Solution for EMI

Senior Research Engineer of MONITOR, R&D CENTER, WOODYOUNG TELECOM CO.,LTD
LEE SEUNG-UN

Model name : HL500M

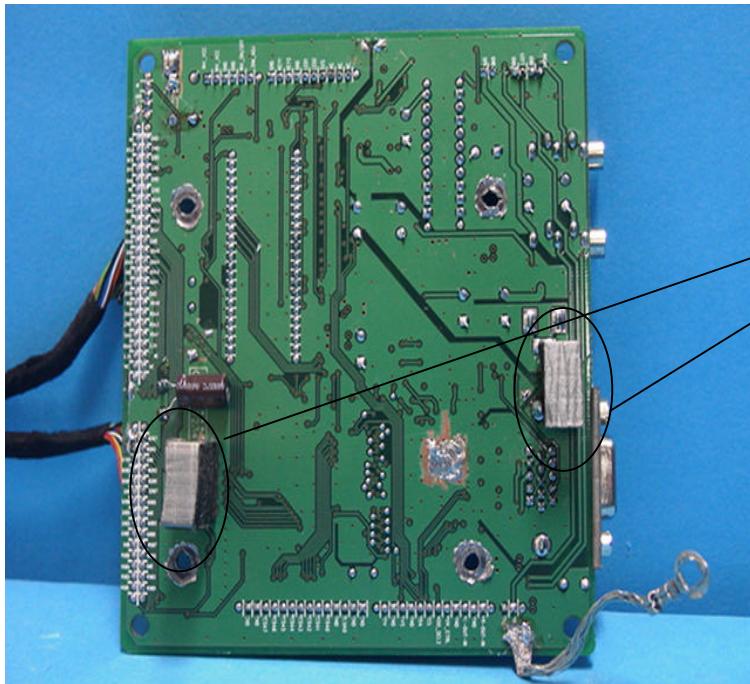
1 Attachment a gasket on the (see the picture below)

2 gaskets on the back side of AD board

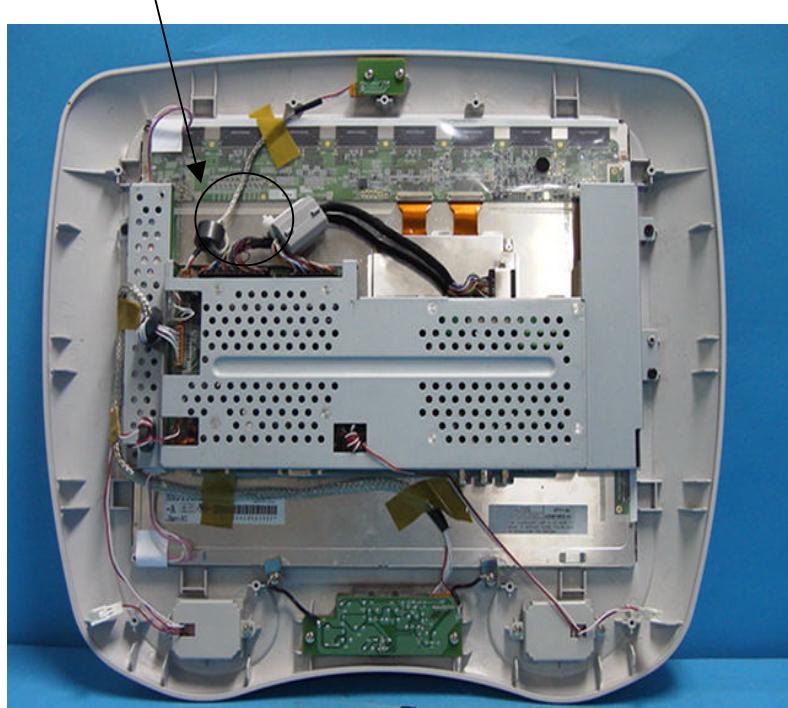
2 Add the core inside the PAN (see the picture below)

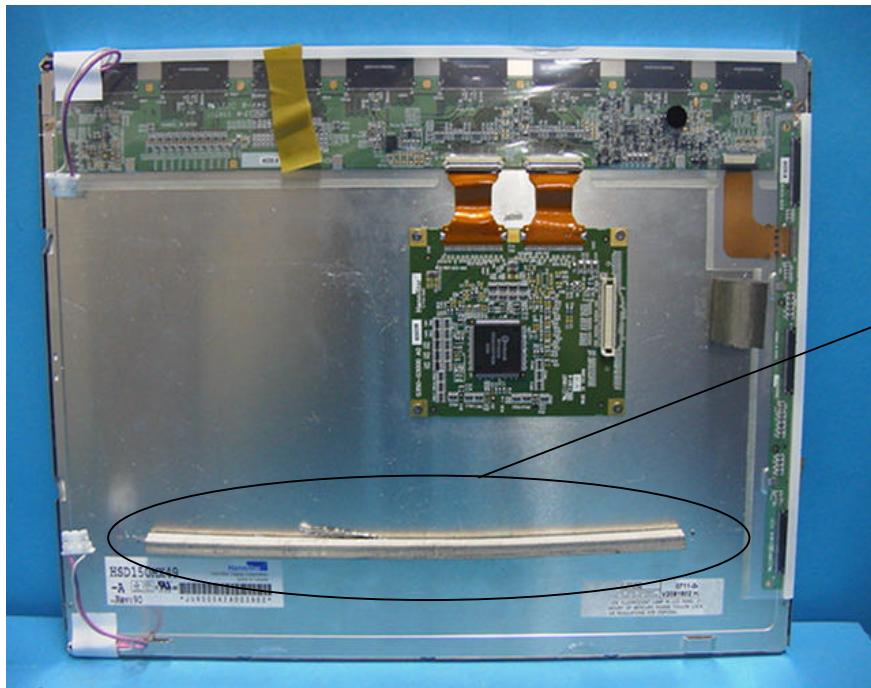
3 Attachment a gasket on the (see the picture below)

1 gaskets on the back side of PANEL

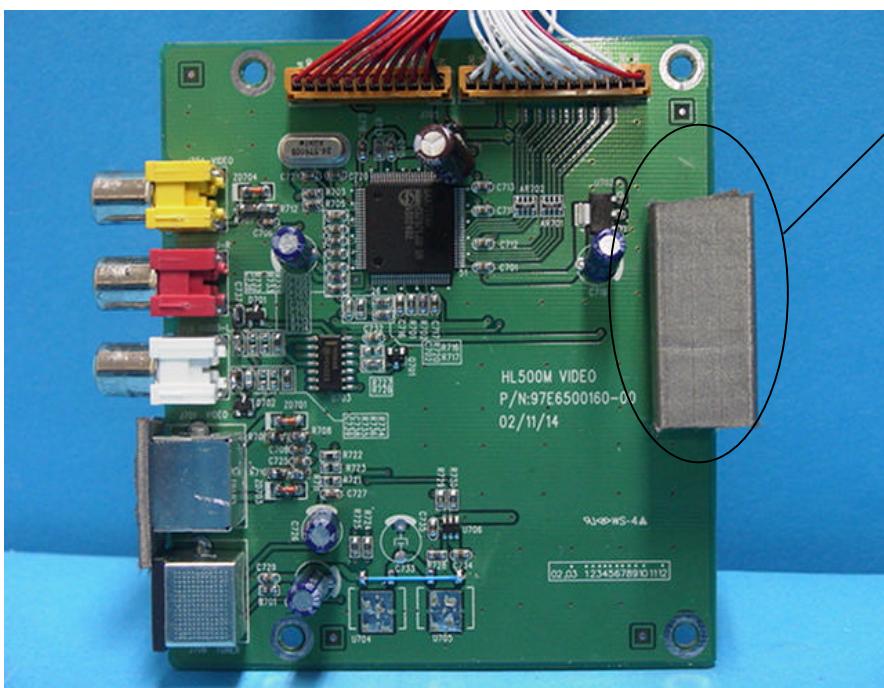
4 Attachment a gasket on the Video BOARD

1 gaskets on the top side of Video board
